MODIFICATION REQUEST:

***Royal Rehabilitation Centre Sydney
(MP 05_0001 MOD 1)***

***Modification of residential layout including
modifications to roads, open space and built
form layouts, building heights and density
within Stage 1.***

Director-General's
Environmental Assessment Report
Section 75W of the
Environmental Planning and Assessment Act 1979

Figure 5: Proposed building layout Stage 1

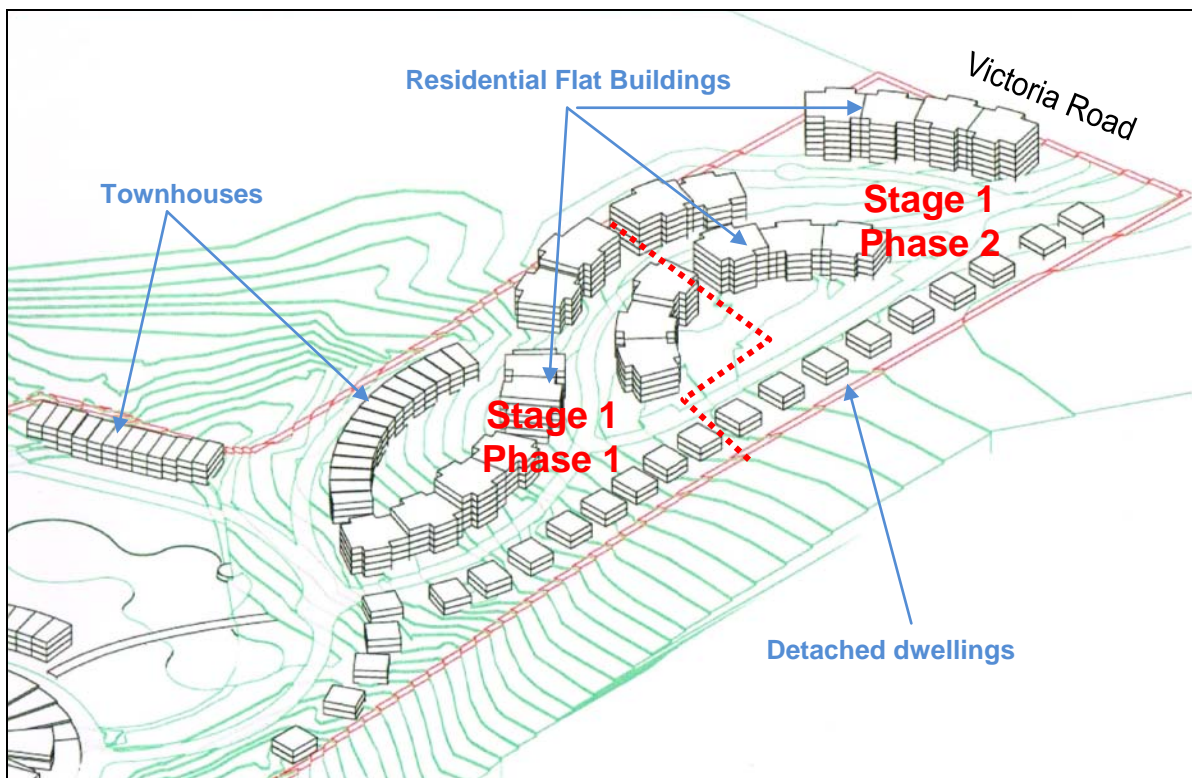
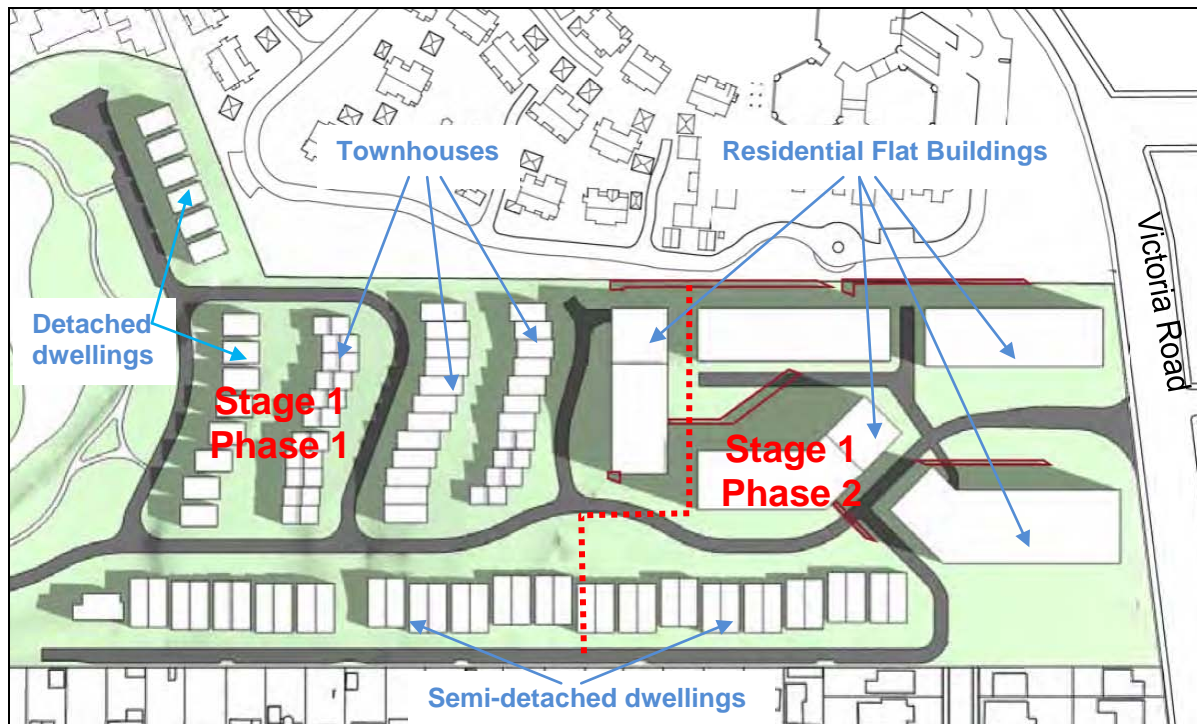
A description of the modifications to Stage 1 Phase 1 is set out in **Table 1 and** depicted in **Figures 4 and 5**.

Figure 7: Proposed Concept Plan Floor Space Ratio Controls

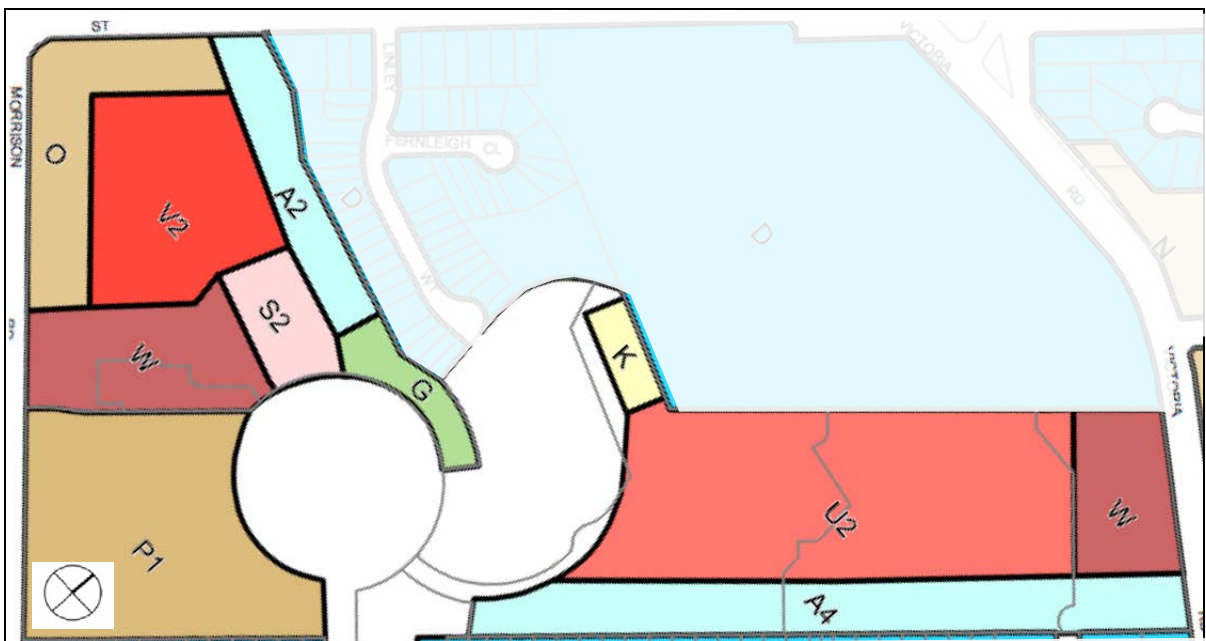
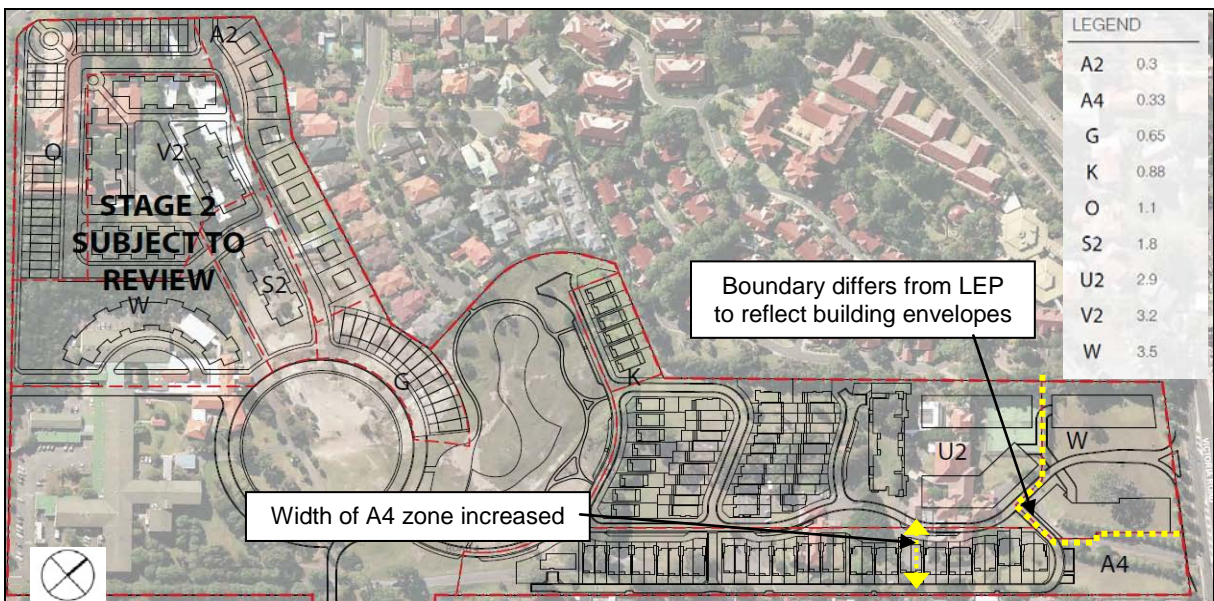
It is proposed to distribute density across the site in line with a new floor space ratio control plan. The plan replaces the existing approved plans PP05/05 and PP06/05, which do not include an FSR control as such, but rather include a residential density control in terms of dwellings per m² and plans showing the gross floor area of each section of the site. A direct comparison with the approved controls is therefore not possible. The proposed new floor space ratio control plan is generally consistent with the Ryde LEP 2010 controls. A small variation is proposed to the boundary of the highest density area "W" and to the width of the "A4" area to reflect proposed building layouts (refer to **Figures 6 and 7**).

The Department supports the provision of greater densities closer to Victoria Road. Dwellings adjacent to Victoria Road are better serviced by public transport along Victoria Road and are within a shorter walking distance (600m) to Ryde City Centre which provides extensive services and retail facilities. This reallocation of density is therefore also consistent with a key strategic direction of the Metropolitan Plan for Sydney which seeks to locate the majority of new homes within the walking catchment of centres with good public transport.

Figure 8: Existing approved Concept Plan Height Controls

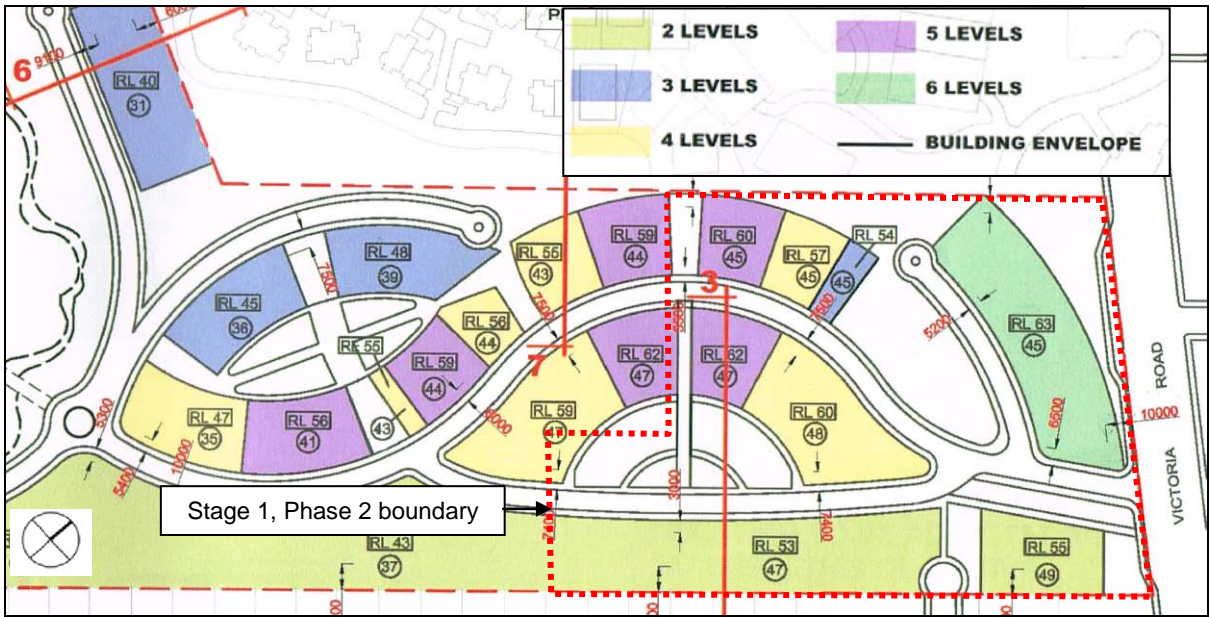
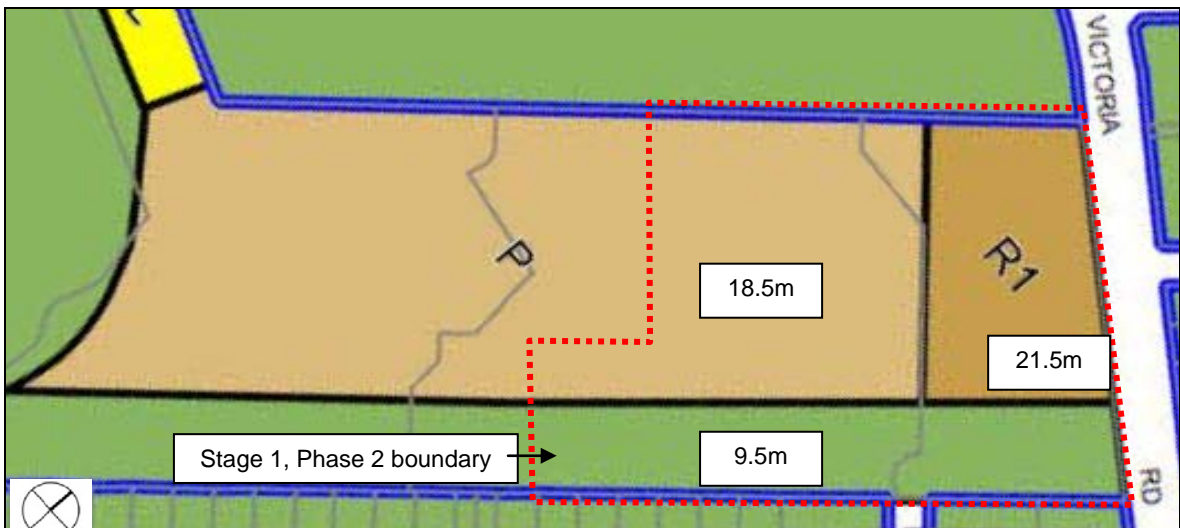
The proposed building heights under the modifications would be greater than the heights established by the existing Concept Approval and current planning controls. The modifications proposed to the building heights are demonstrated in **Table 2** and depicted in **Figures 8, 9 and 10**.

As discussed in **Section 5.1**, the Department supports greater densities of development close to Victoria Road, and consequently greater heights are also supported in this location, subject to the assessment of potential amenity impacts arising from the proposed heights.

The proposed increase in height along the eastern boundary to 9.5 metres is supported as it is consistent with the Ryde LEP 2010.

The remaining four residential flat buildings would present as 3m – 6m (1 – 2 stories) higher than anticipated under the Ryde LEP controls. Given the height variation, the Department has carried out an assessment in respect of:

Figure 11: Extract from subdivision plan submitted with the modification indicating future boundary with Victoria Road

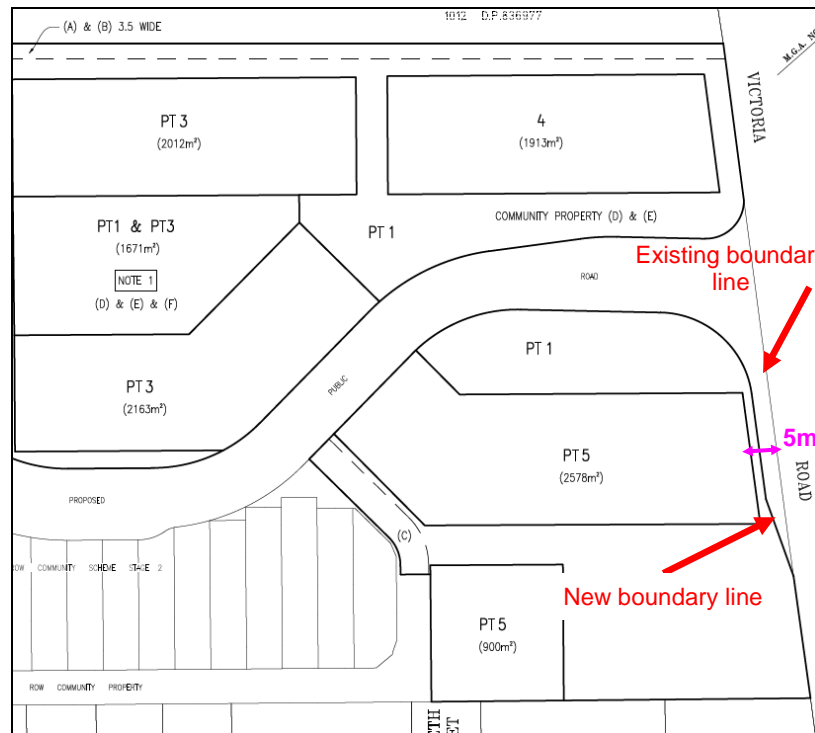
In terms of depth of landscaping, the proposed setback of 5 metres to the eastern building shown on the Concept Plan drawings does not take into account the new deceleration lane on Victoria Road and associated area to be dedicated to the Council as part of the road reserve to accommodate pedestrian pathways. It is estimated that once the new boundary with the road reserve is established, the building envelope of the eastern building on Victoria Road would have an approximate setback of only about 2 metres from the boundary. Also, the proposal seeks to provide basement parking in part of the front setback areas.

As discussed below in **Section 5.3**, the Department recommends that, as a minimum, the proposed setback of the eastern building envelope should be at least 5 metres from the new boundary with Victoria Road, following the dedication of land as road reserve. A 5 metre setback is the minimum necessary to allow for a sufficient depth of landscaping to make a reasonable contribution to the streetscape, mitigate the visual impact of the proposed eight storey building, and allow for the proposed transplanting of the palm trees.

Also, the Department recommends that all front boundary setback areas be provided as deep soil landscaped areas to enable landscaping to be maximised and to ensure the longevity of the proposed boundary tree plantings.

Figure 12: Proponent's comparison of approved and proposed building envelopes as viewed from Victoria Road

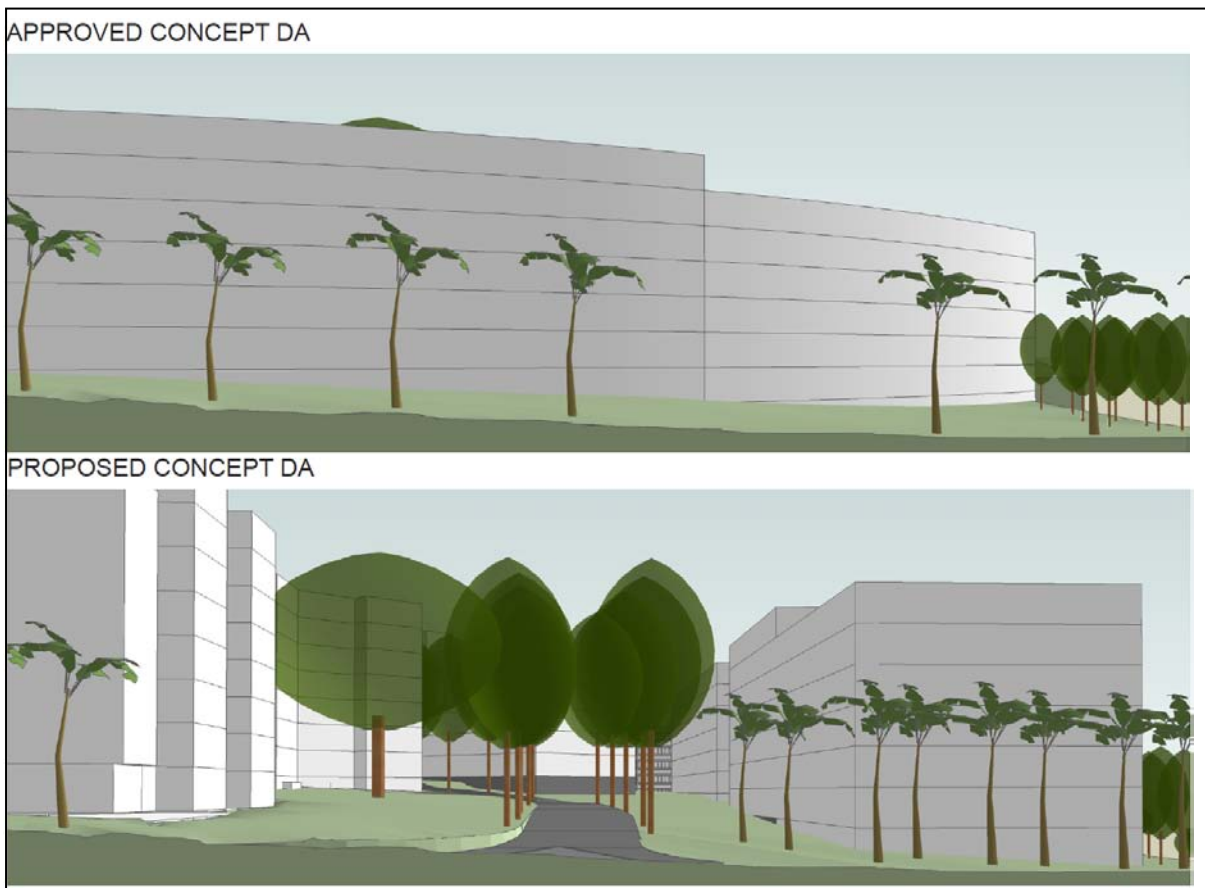
The proponent provided a visual comparison of the existing and proposed envelopes (**Figure 12**). They also provided indicative landscape plans to demonstrate potential front boundary plantings and a certified photomontage of the building envelopes as viewed from Victoria Road (**Figure 13**).

The Department agrees that the re-orientation of the buildings to allow for views into the site represents an improvement to the appearance of the site within the streetscape.

While the proposed height can therefore be supported, in conjunction with the reduced front setbacks, the proposed building envelopes have the potential to result in development that has an overbearing visual impact on the streetscape. As discussed above in **Section 5.2**, setbacks should be sufficient to provide a depth of landscaping to soften the appearance of future buildings, mitigate against overbearing visual impacts, and make a positive contribution to the streetscape of Victoria Road. The approved Statement of Commitments also provides that the proponent will: “*setback buildings from street frontages to create landscaped settings*”.

Figure 15: Proposed consolidated basement car parking areas

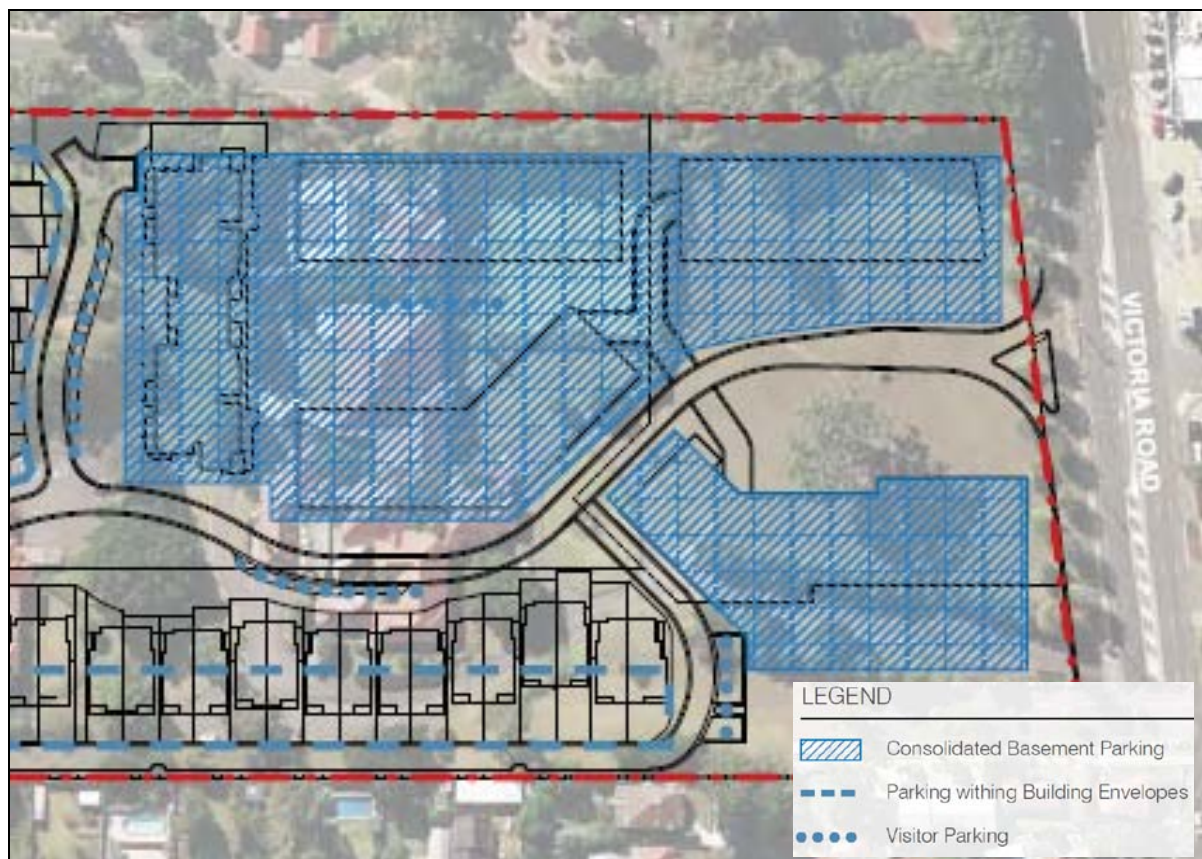
Another proposed modification which impacts open space is the proposed provision of basement car parking in areas beyond the proposed building envelopes below proposed open space (refer to **Figure 15**). Basements in the existing Concept Plan approval were limited to areas below the building envelopes and a small section of roadway.

As discussed in **Section 5.2**, basement parking in the front setback is not supported and a condition modifying the approval is recommended. Basement parking under other open space areas is acceptable, providing future applications can demonstrate compliance with Council's stormwater management requirements and can provide appropriate drainage and soil depths to support a variety of landscaping including mature trees to a height of at least 10 metres. These requirements are reflected in the recommended conditions.

Figure 16: Existing bus stops in proximity to the site.
Distance of closest stops to the Victoria Road pedestrian entrances.

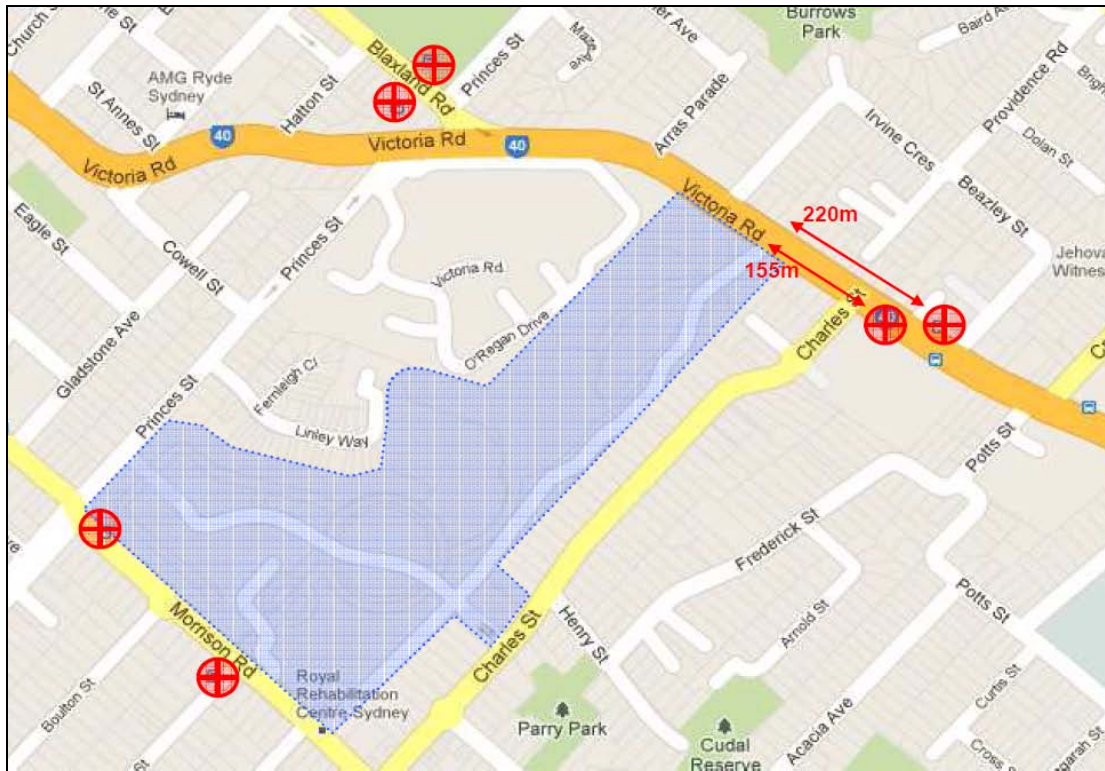
Existing bus stops are located on Victoria Road to the east of Charles Street as shown in **Figure 16**. They are within the 400 metre walkability criteria established in the *Planning Guidelines for Walking and Cycling*. Blaxland Road bus stops are around 390m from pedestrian entrances to the site and therefore also within the accepted range. Therefore the existing access to bus services is adequate.

Therefore the Department has previously accepted changes to the Victoria Road frontage that did not include a bus loading bay and had previously found that existing access to bus services is adequate.
